# ATTACHMENT A

DATE: May 4, 2022

**TO:** Design Review Commission  
**FROM:** Jia Liu, Associate Planner  
**SUBJECT:** SC21-0046 – 628 Cuesta Drive

EXISTING /  
 PROPOSED  
 SITE PLAN

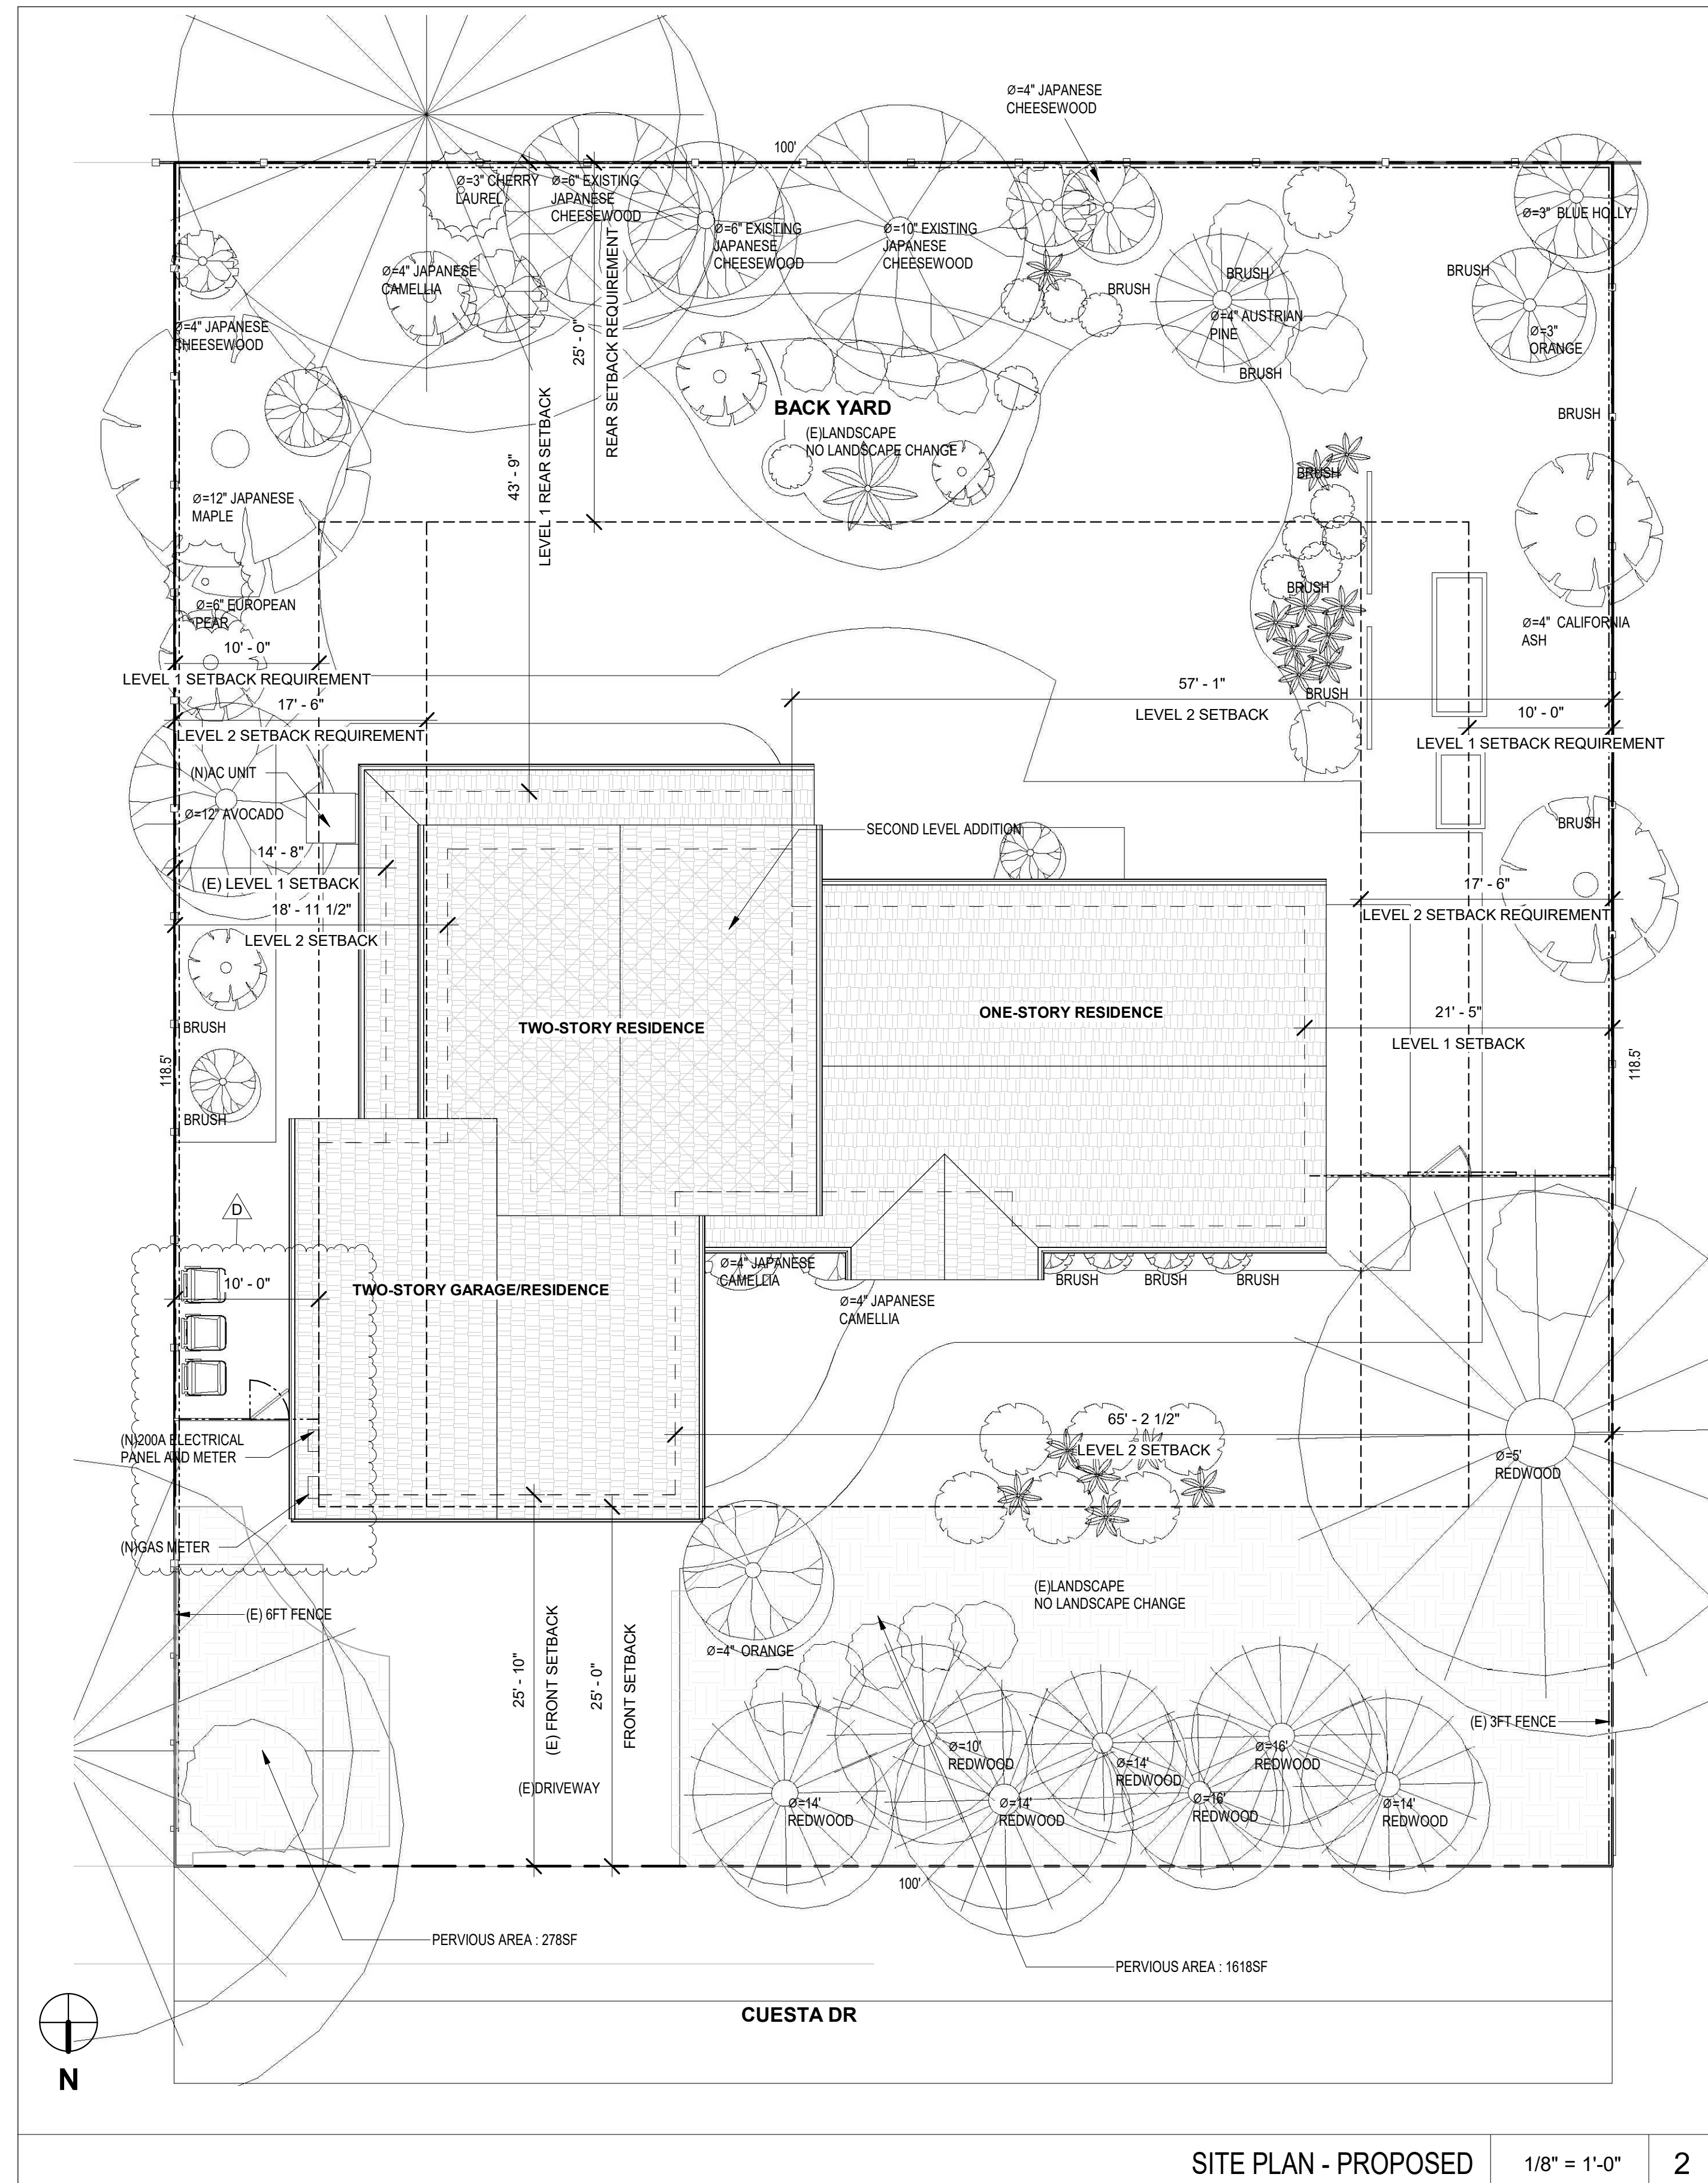
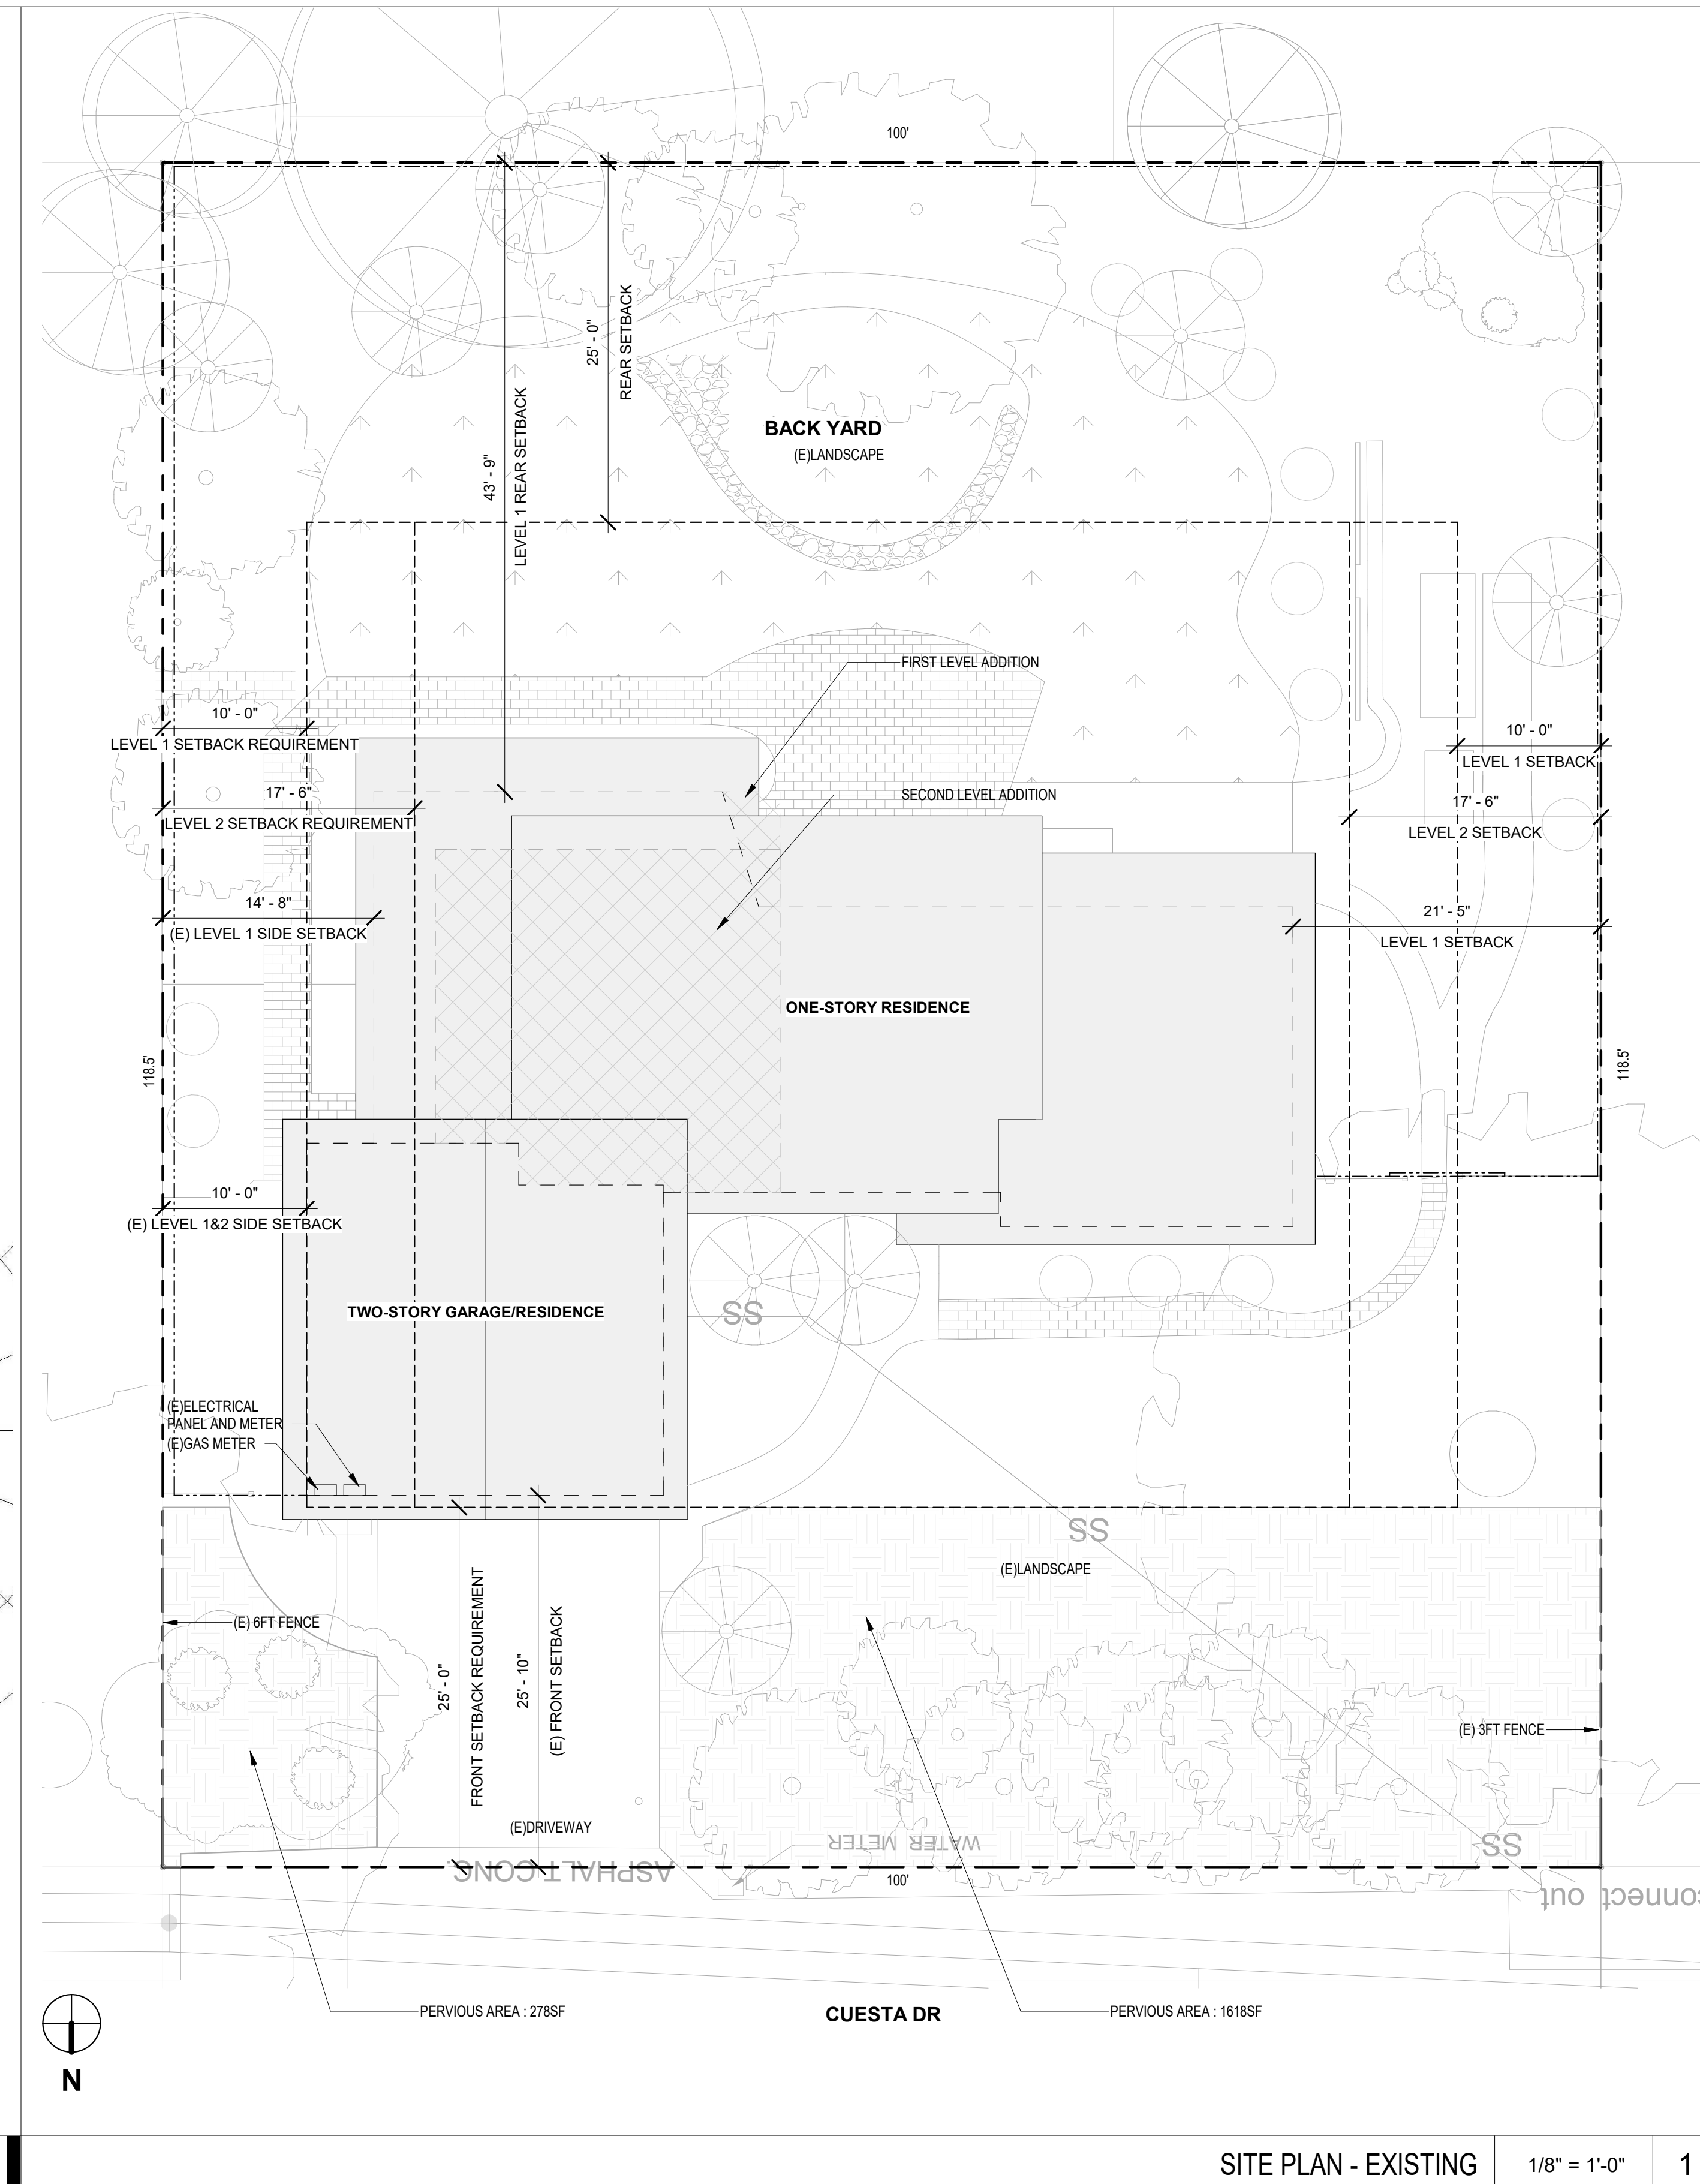
It should be noted that the applicant did not include the new porch into the proposed site coverage. As a condition of approval, the applicant shall include the proposed porch into the lot coverage in the construction drawings.

Update the construction drawing on Sheet A-1, the “Proposed Lot Coverage” shall be revised from 2,066 square feet to 2,113 square feet to include the proposed porch.

TREE  
PROTECTION  
PLAN

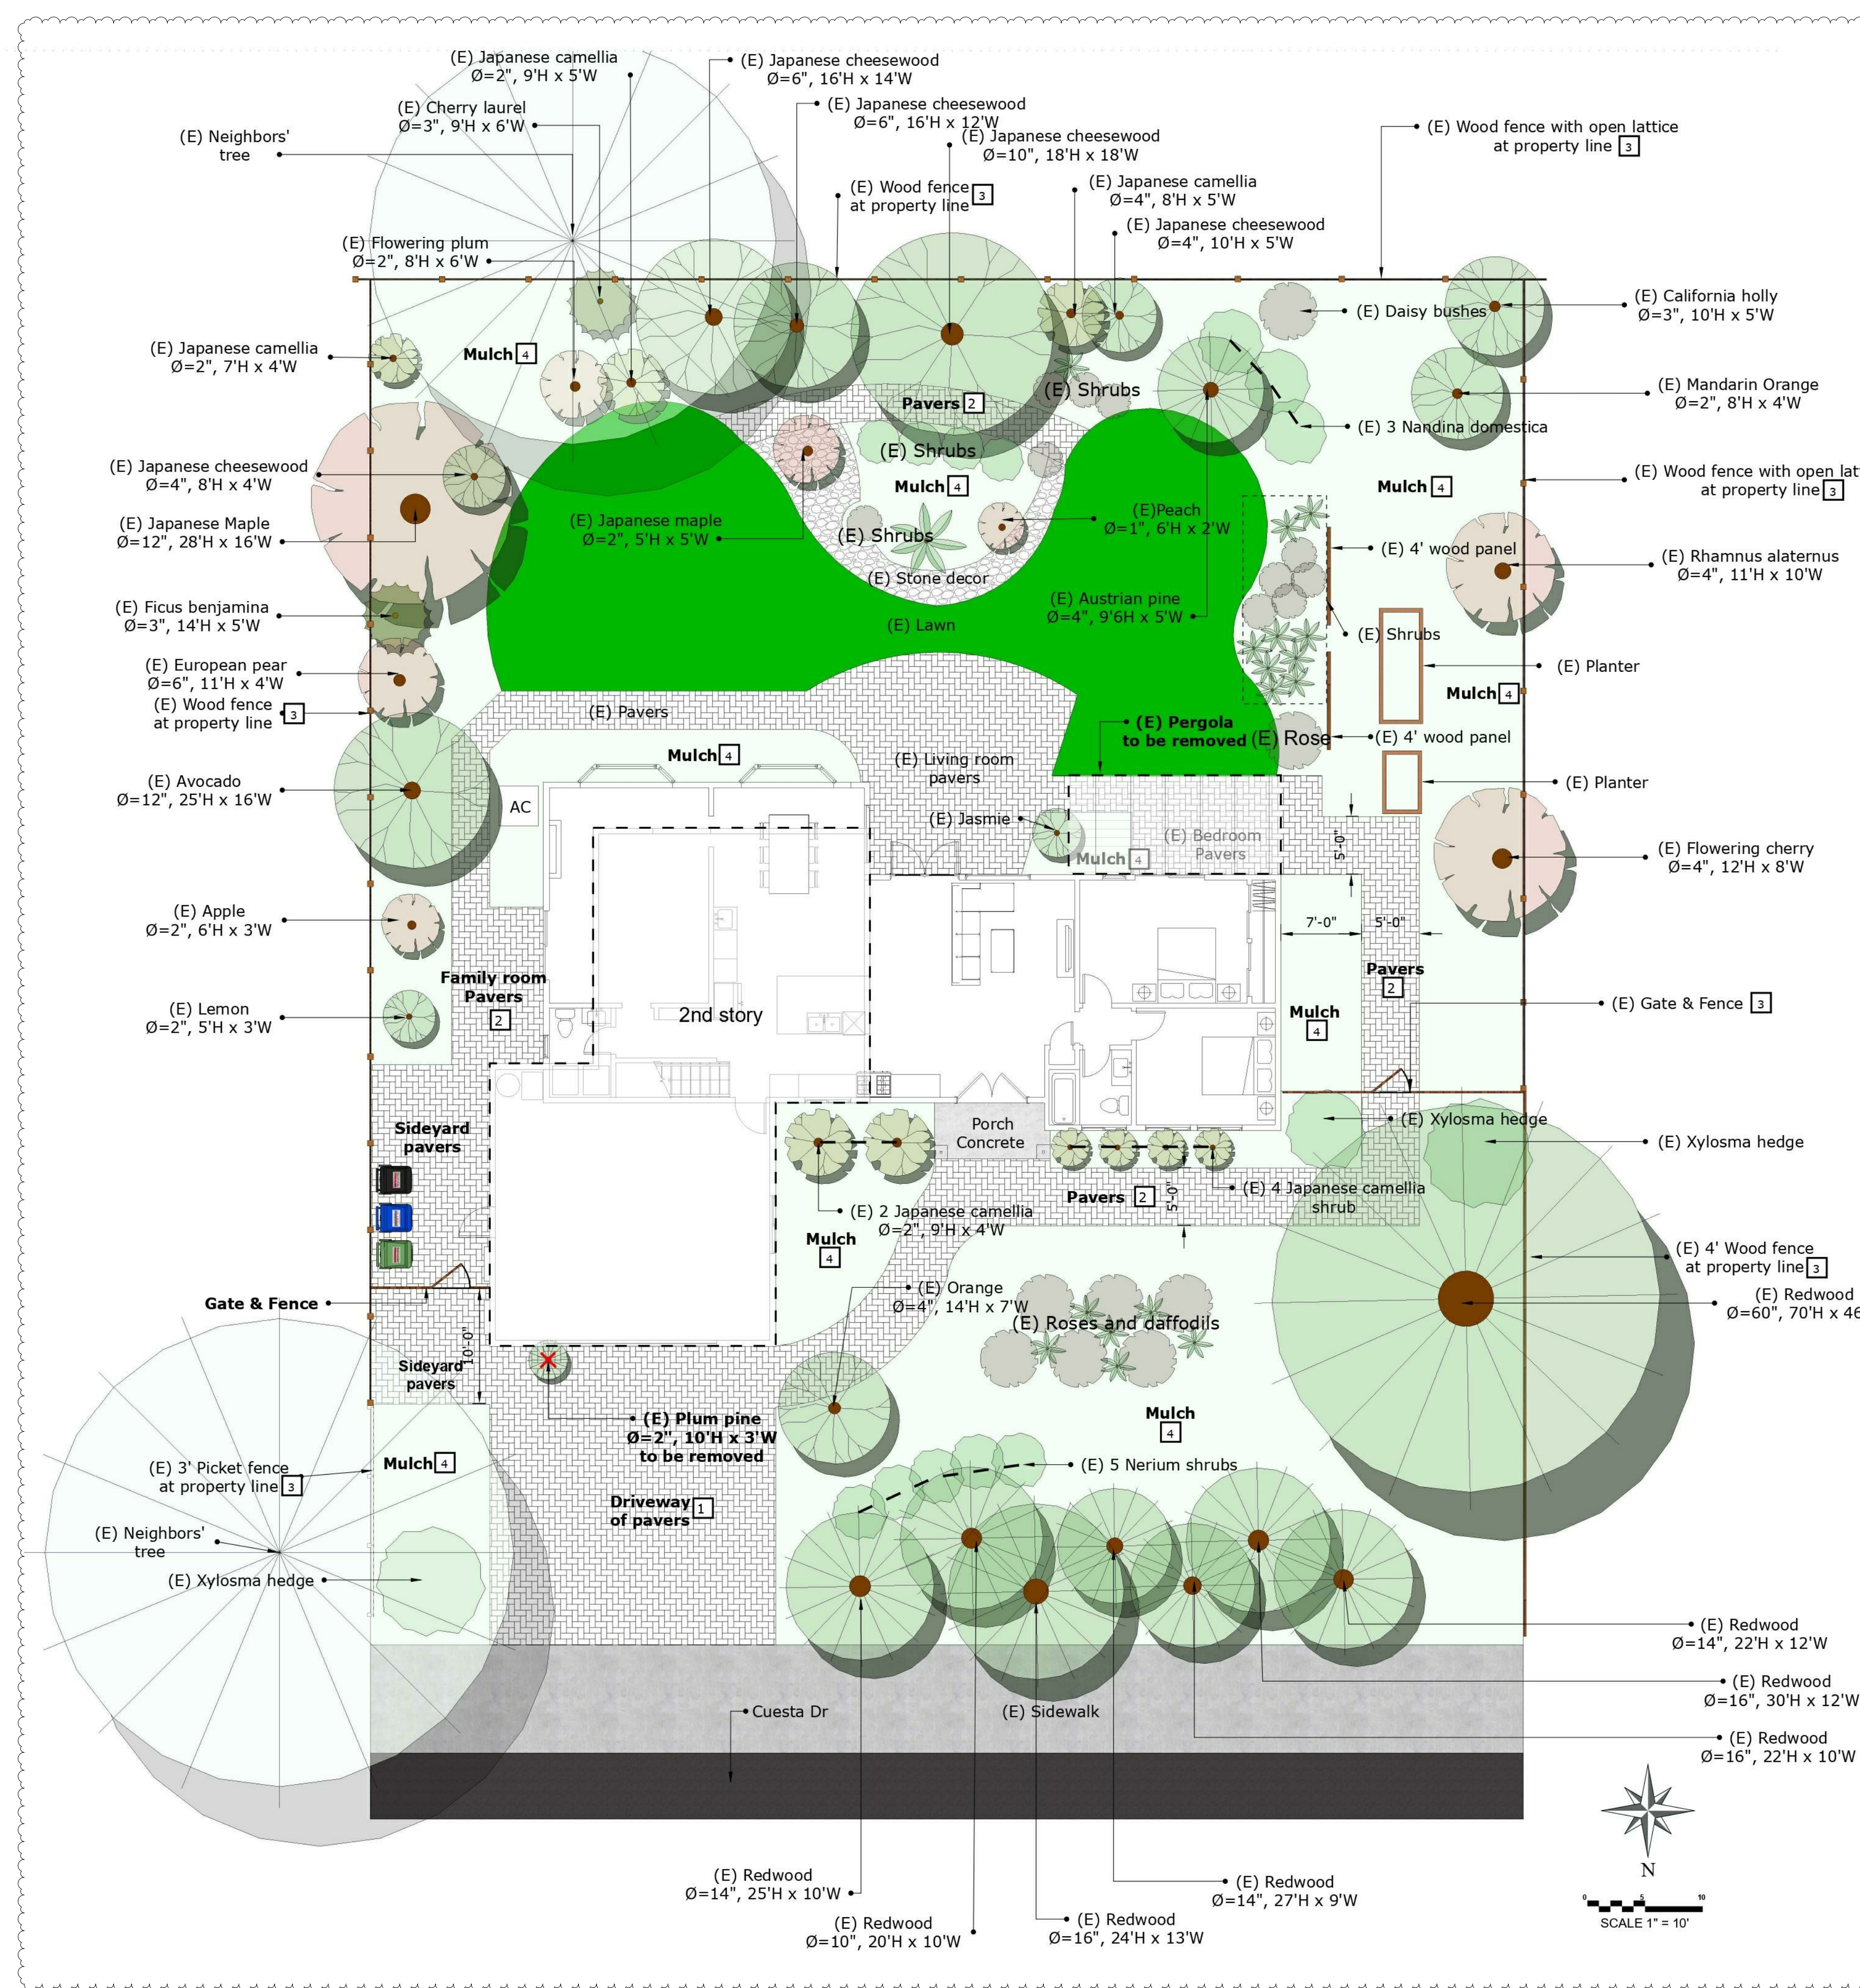
Trees Nos. 1-8, 16-21, and 25 shall be protected under this application and cannot be removed without a tree removal permit from the Community Development Director.

Tree protection fencing shall be installed around the driplines of trees Nos. 1-8, 16-21, and 25 as shown on the Tree Protection Plan. Tree protection fencing shall be chain link and a minimum of five feet in height with posts driven into the ground and shall not be removed until all building construction
